# Service Manual

Equalizer

SH-8075

Please file and use this supplement manual together with the service manual for Model No. SH-8075, Order No. SD83072619C2.

### ■ SCHEMATIC DIAGRAM

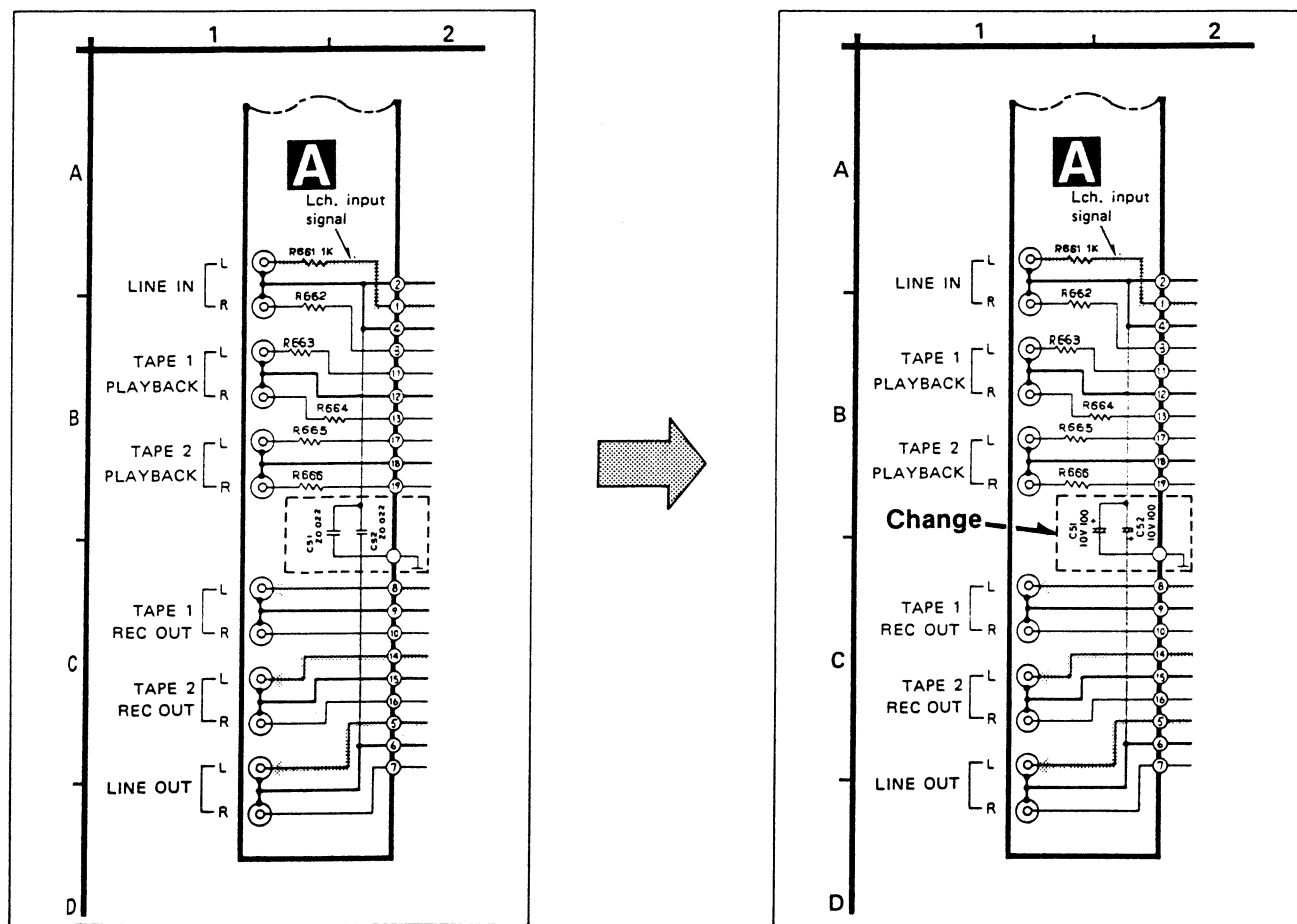
- This supplement has been issued to inform you that the input circuit has been changed in units having serial number suffixes "C" or later. (Refer to "How to read the serial number" on page 2.)

Ref. No.	Change of Part No.		Description	Remarks
	OLD	➡ NEW		
CAPACITORS				
C51, C52	ECKD1H223ZF	ECEA1AK101	Electrolytic, 10 V, 100 μF	Change
